RE: NORTHPORT – SUPPLEMENTARY INFORMATION

Please see below and **attached** supplementary information in response to the Section 92 clarifications letter dated 5 July 2023.

Figure 1: Plan showing container terminal/Berth 4 overlap

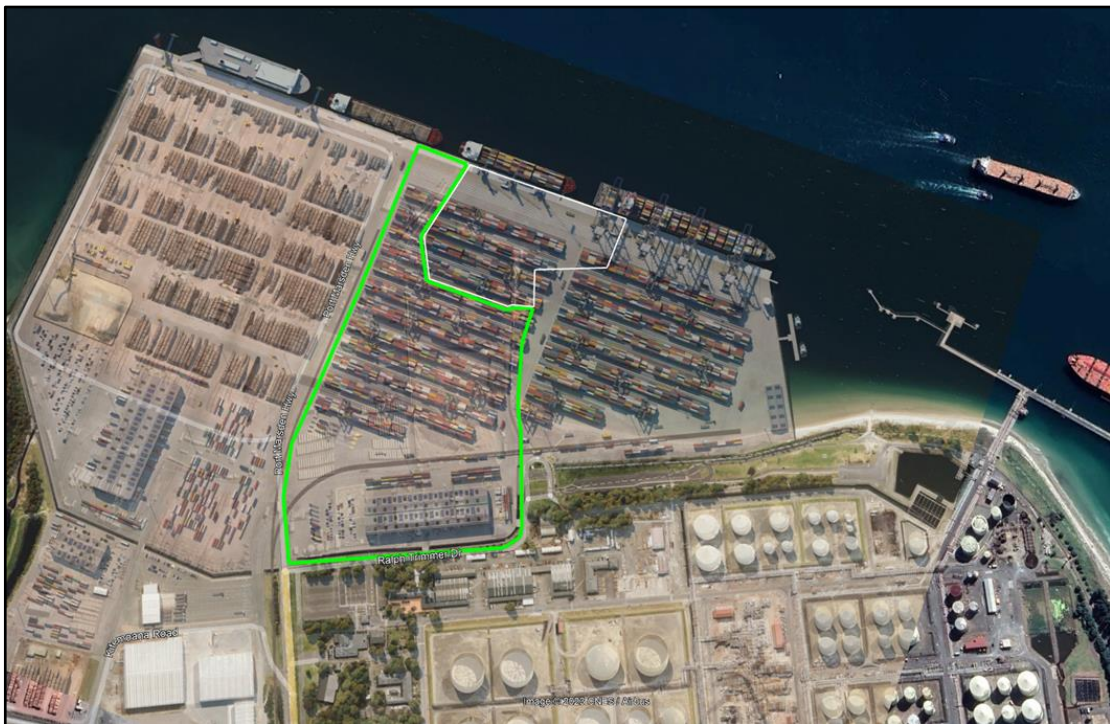
- The area needed for the container terminal cannot be accommodated wholly within the existing Northport facility. Northport has confirmed that to run an efficient bulk port (logs, general cargo etc) now and into the future, the existing trades require the majority of the existing port area. The proposed container terminal does occupy approximately 10-15ha of Northport's existing (or consented) reclamation (behind Berth 4) (see **Figure 1** below).

Figure 2: 60m occupation area (Berths 1-4 consents)

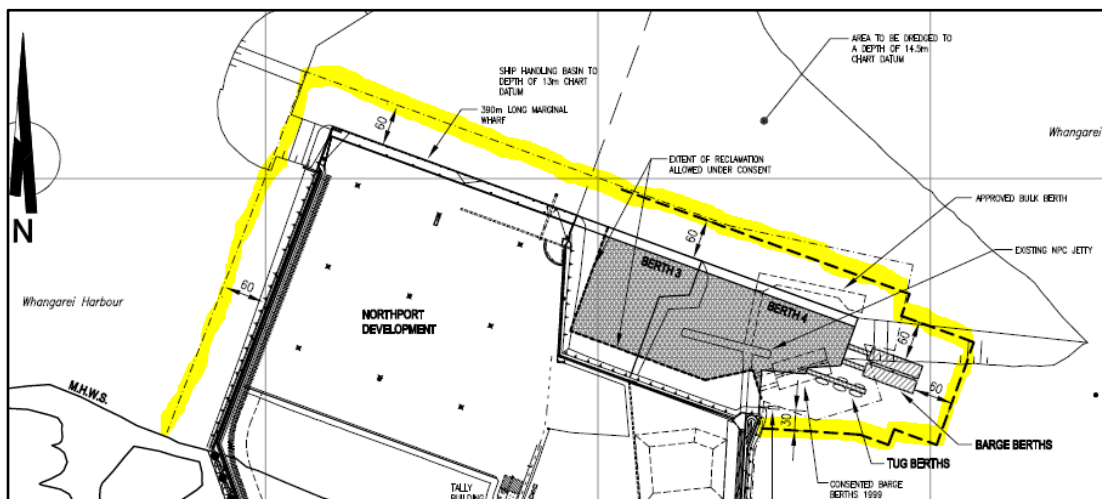
11.1 The existing Northport resource consents include a 60m occupation area extending from the western revetment, from the wharves, and around the tug and barge berths (see **Figure 2** below).

11.2 It is not an “exclusive” occupation area. Rather, it is a right to occupy seabed and water space for new wharves and related structures, barge berths, tug berths and water taxi services, and the occupation of water space for activities in relation to those structures.

Figure 3: Prohibited area (Schedule 2 of the Northland Regional Council Navigation Safety Bylaw (2017).

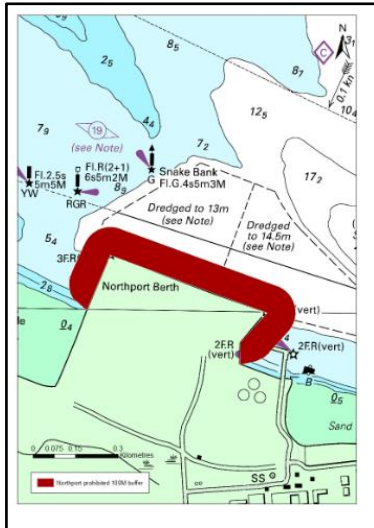
11.3 The 100m prohibited area is under Schedule 2 of the Northland Regional Council Navigation Safety Bylaw (2017) (see **Figure 3** below). This 100 m exclusion zone applies when ships are fumigating, bunkering, discharging or loading dangerous cargo. This area is unrelated to the existing resource consents under the RMA.

Figure 4: Berth 3 and 4 consent plan (approved)

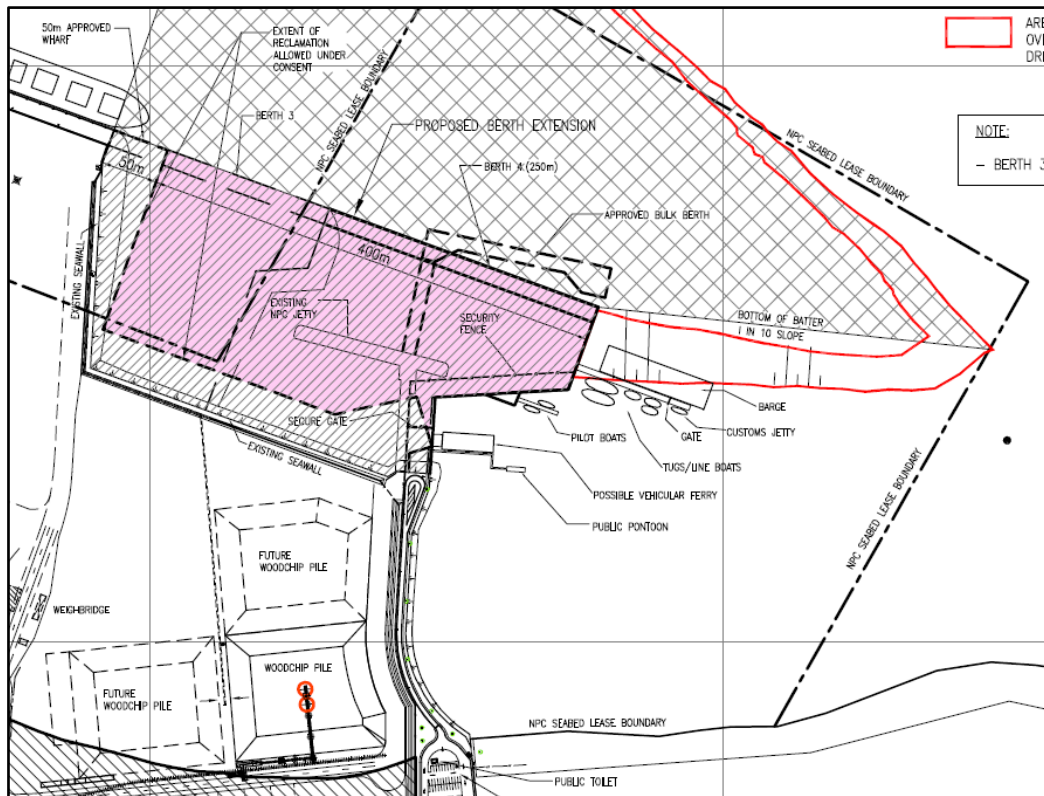
12.2 It is important to appreciate what comprises the “existing environment” upon which the effects of the proposed expansion are to be assessed. Specifically, the existing tug facility located within the quay at the north-eastern corner of the port is not the final consented configuration. The final configuration is shown on the plan in **Figure 4** below. We refer in particular to the proximity of the tug facility, pilot boat facility, and the public pontoon.
